NAME OF PROJECT: **Johnson Ranch**; Located at the northeast corner of the intersection of US 281 and FM 1863; Bulverde, Texas

TYPE OF PLAN: Request for Modification of an Approved Water Pollution Abatement Plan (WPAP); 30 Texas Administrative Code (TAC) Chapter 213 Edwards Aquifer

RE: Johnson Ranch WPAP Modification

This letter is submitted on behalf of the owner, DHJ Development, LLC, in support of the WPAP Modification for Johnson Ranch in response to comments issued September 24, 2012.

Official 7 1/2 Minute USGS Quadrangle Map of the Edwards Recharge Zone

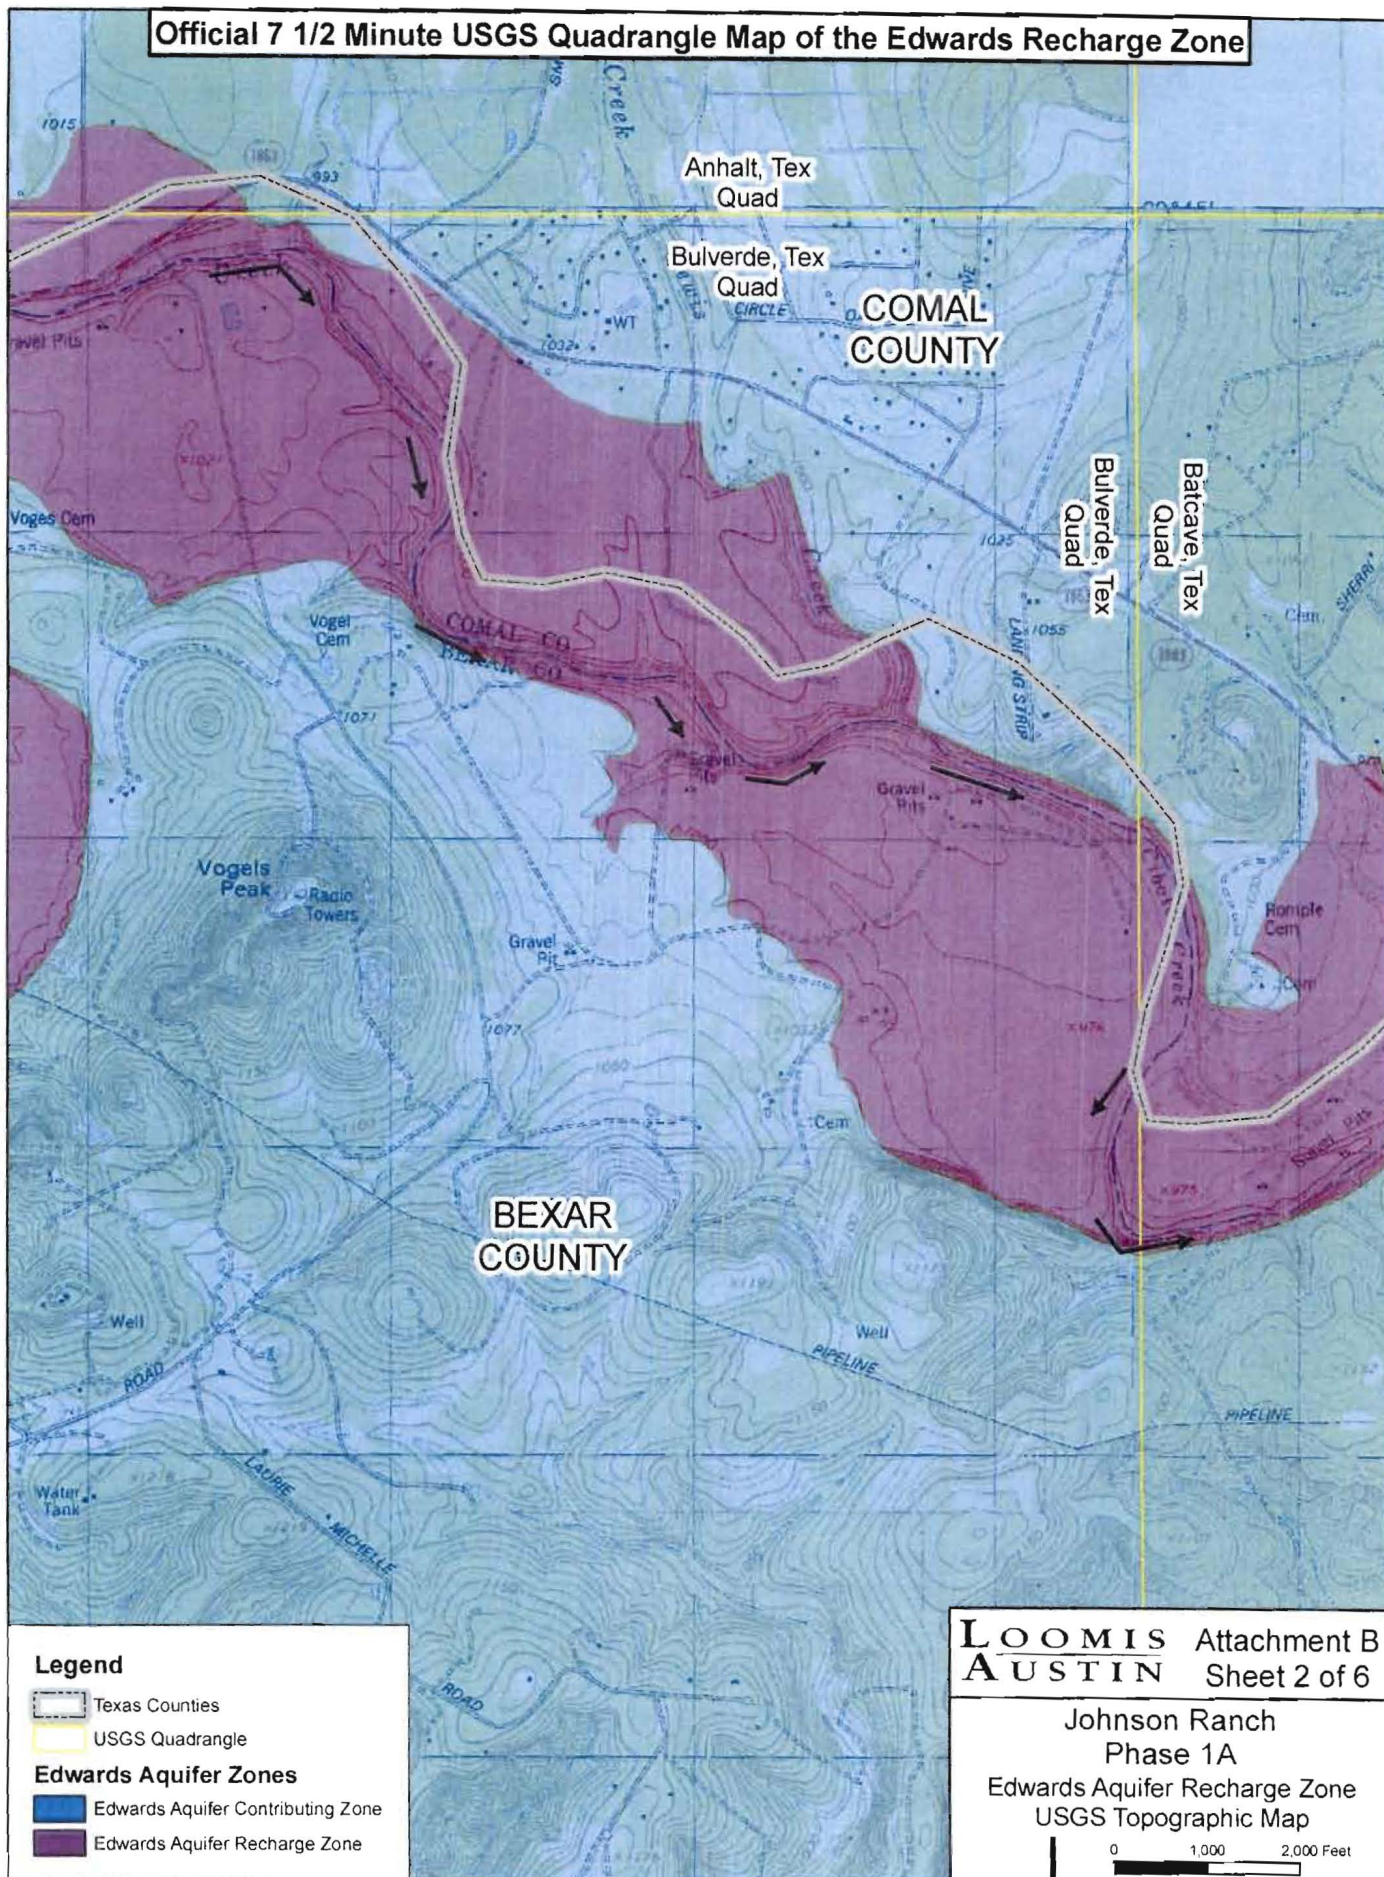
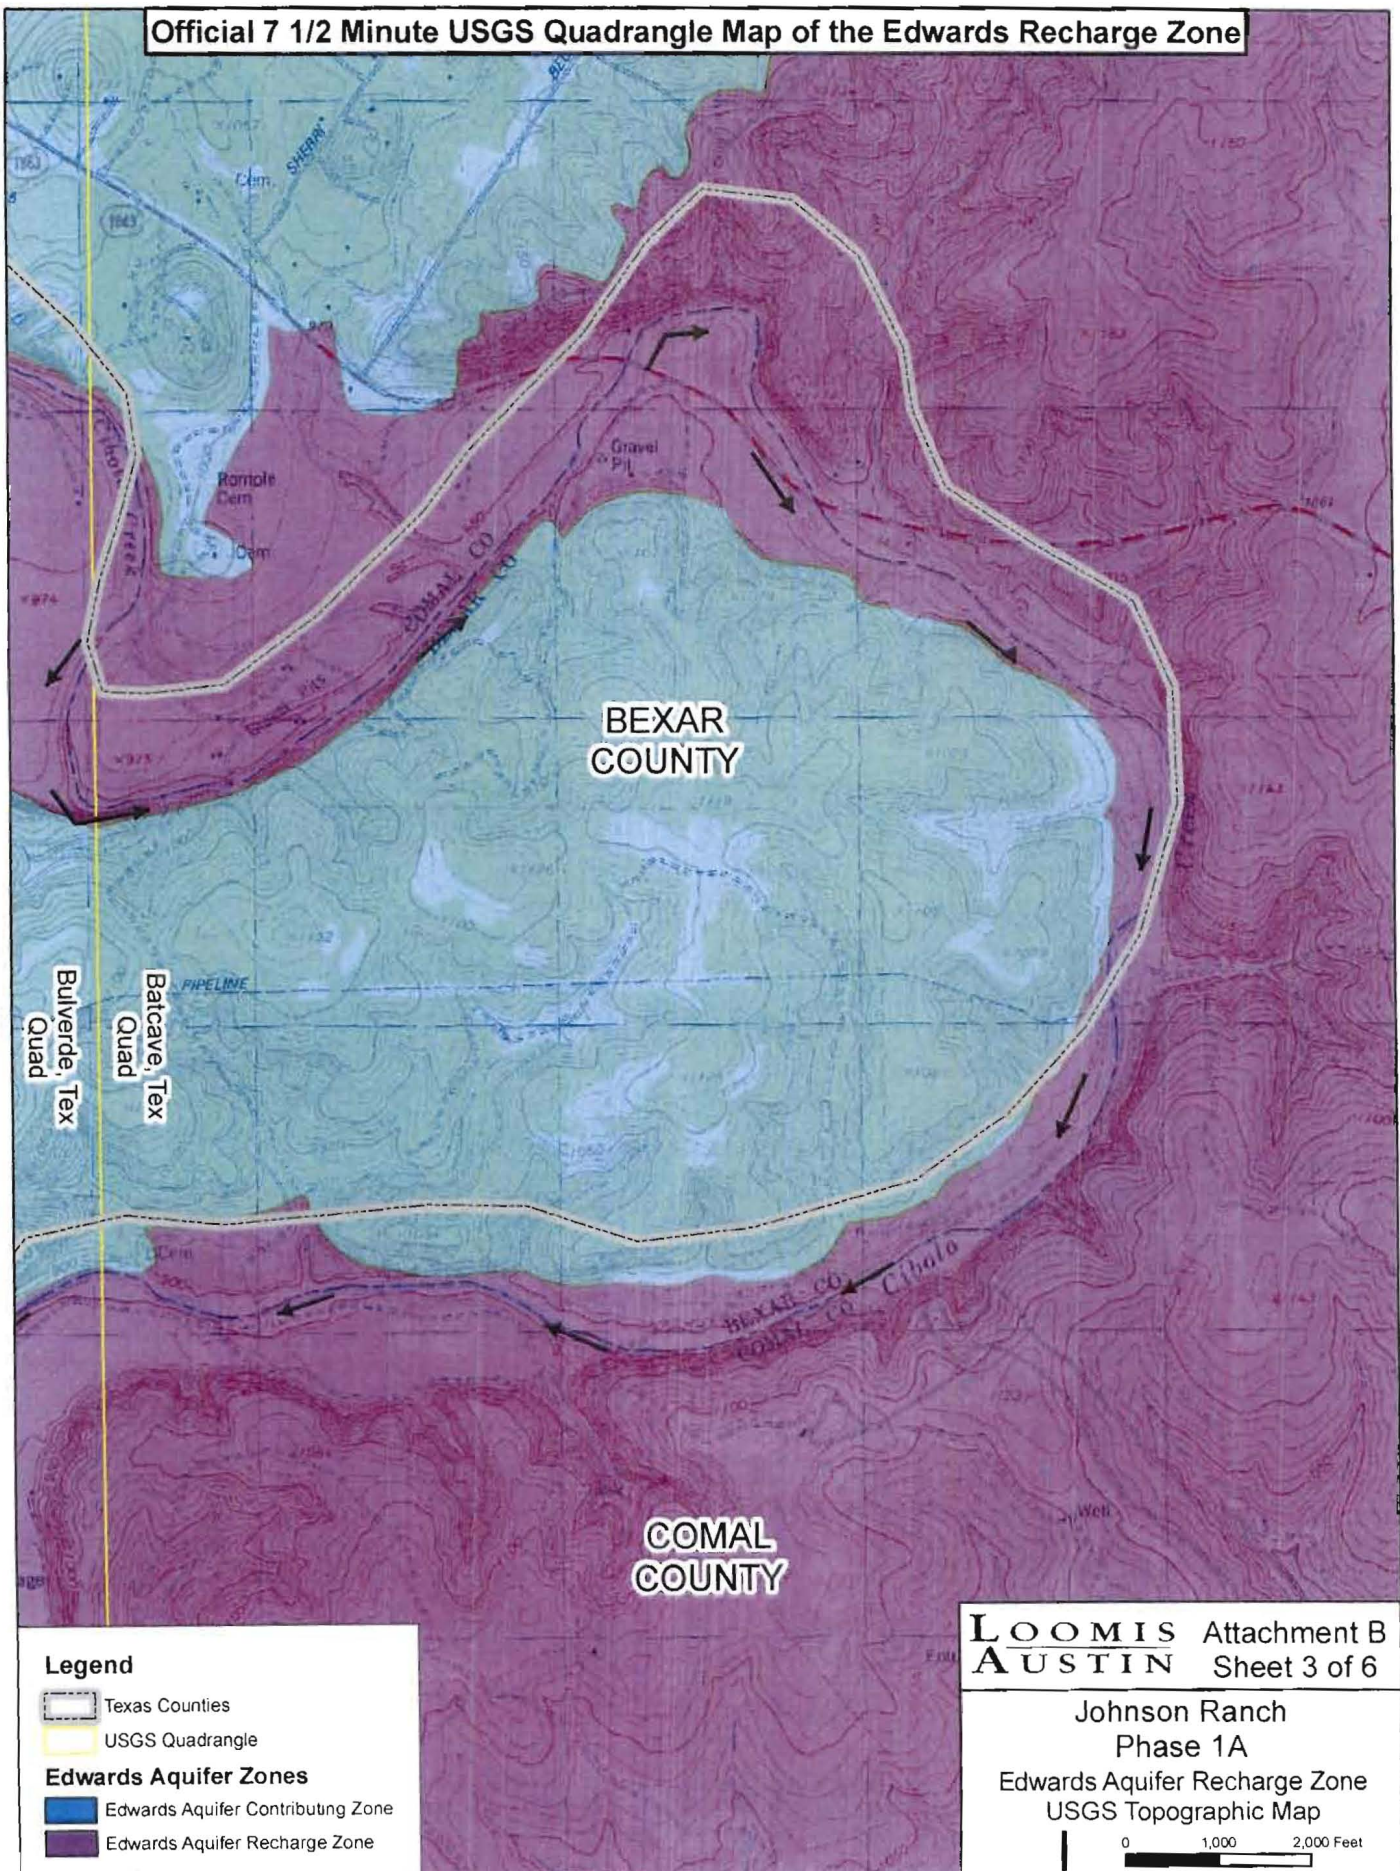
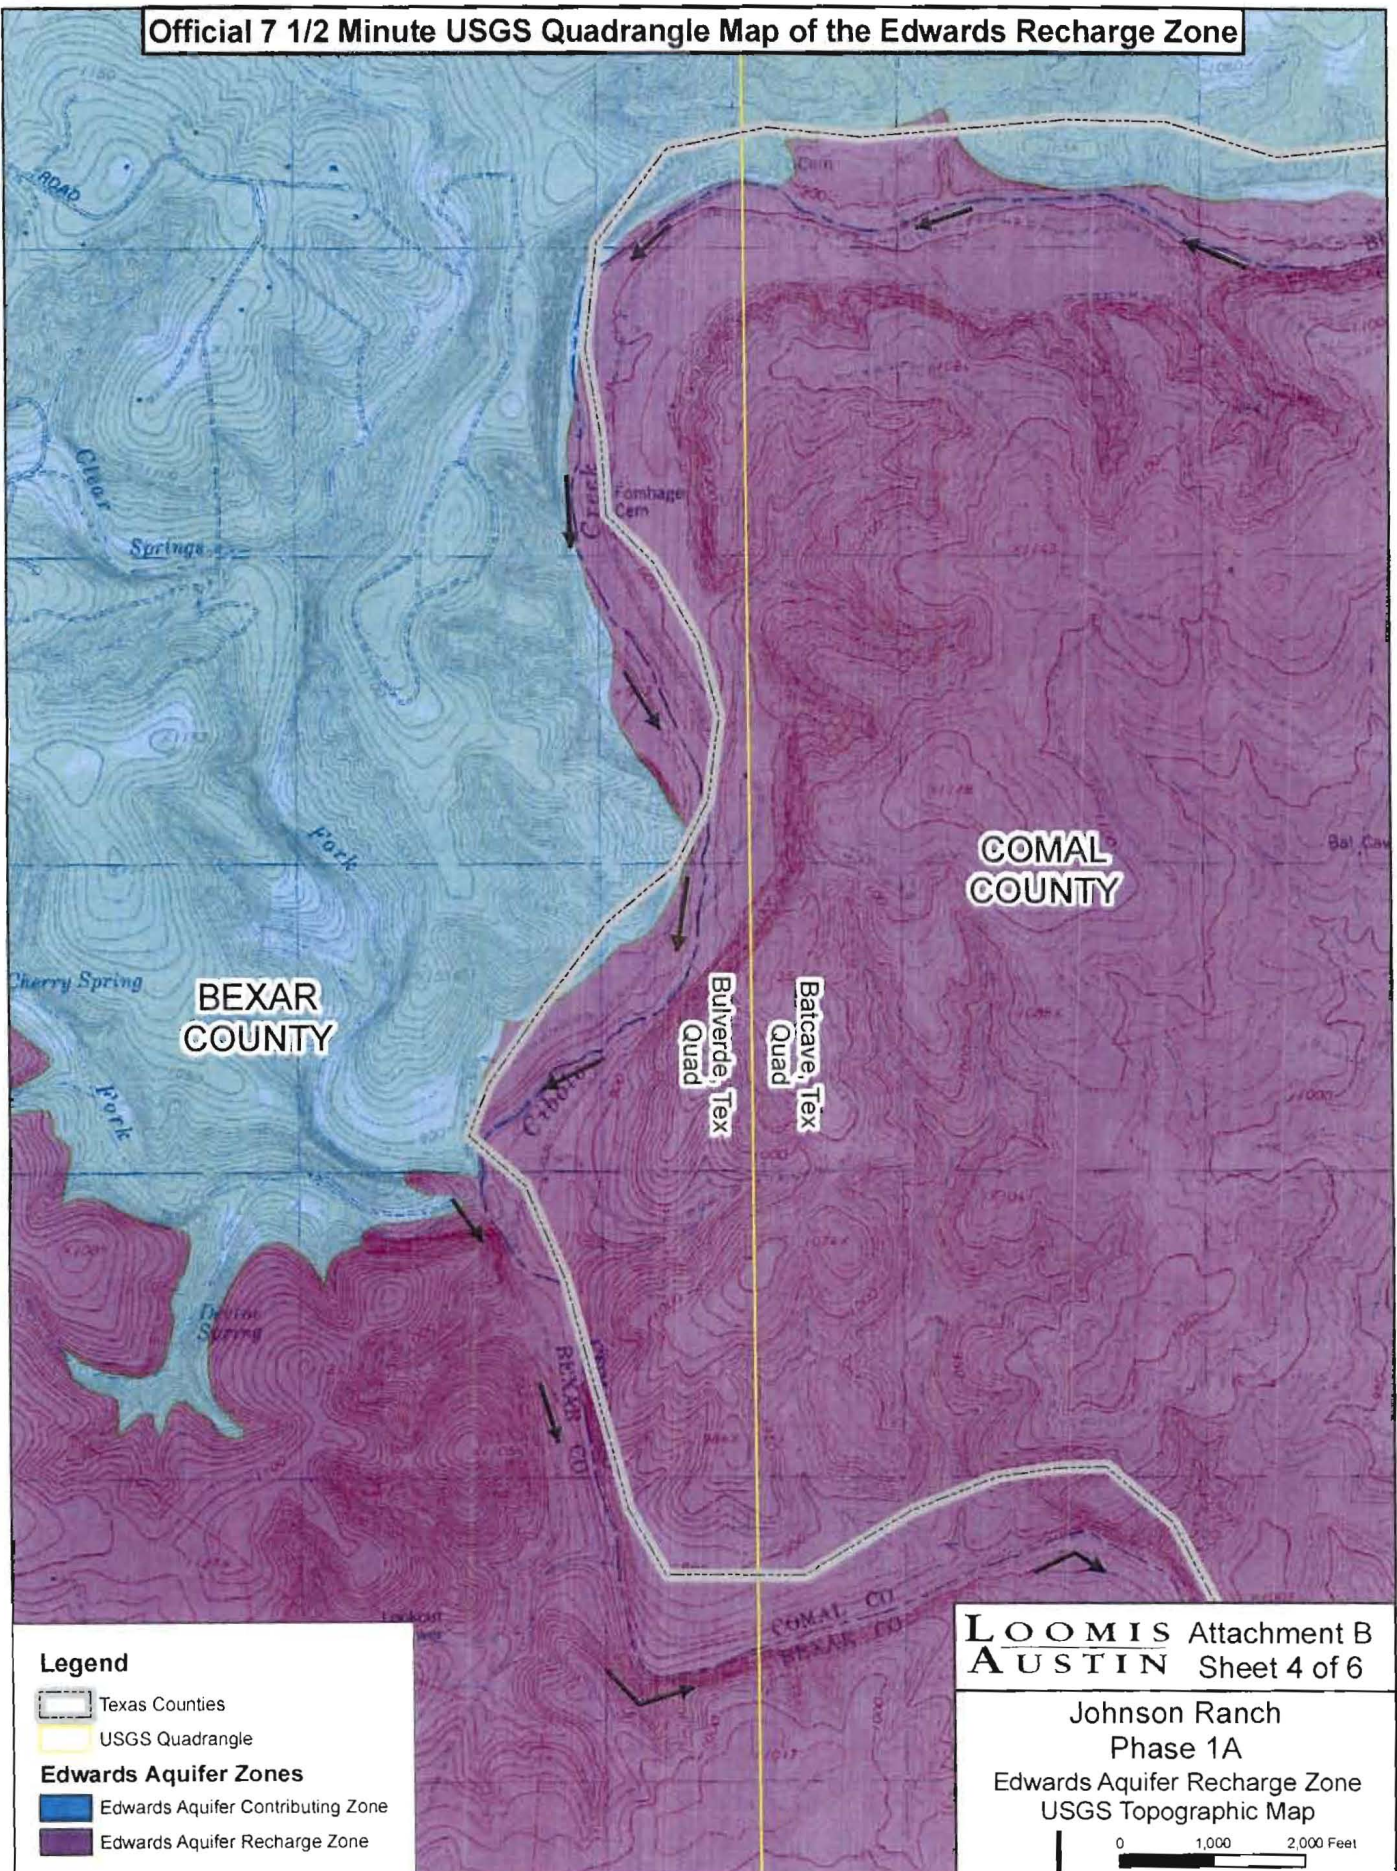
1. Please revise Project Description (Attachment C/General Information Form) to include reference to the actual modification including Unit 1 (Phases 1 and 2), Unit 2, Unit 3, Unit 4 and Unit 5 for clarification to reader. Revising the Attachment B (General Information Form) map to show the location of Units 1 through 5 would be most helpful to the reader.

Response: Attachments B and C of the General Information Form have been revised as requested and are attached.

The current WPAP modification will include Units 1, Phases 1 and 2, Unit 2, Unit 3, Unit 4, and Unit 5. These sections are labeled on Attachment B, USGS 7.5 Minute Quad of the Edwards Aquifer Recharge Zone.
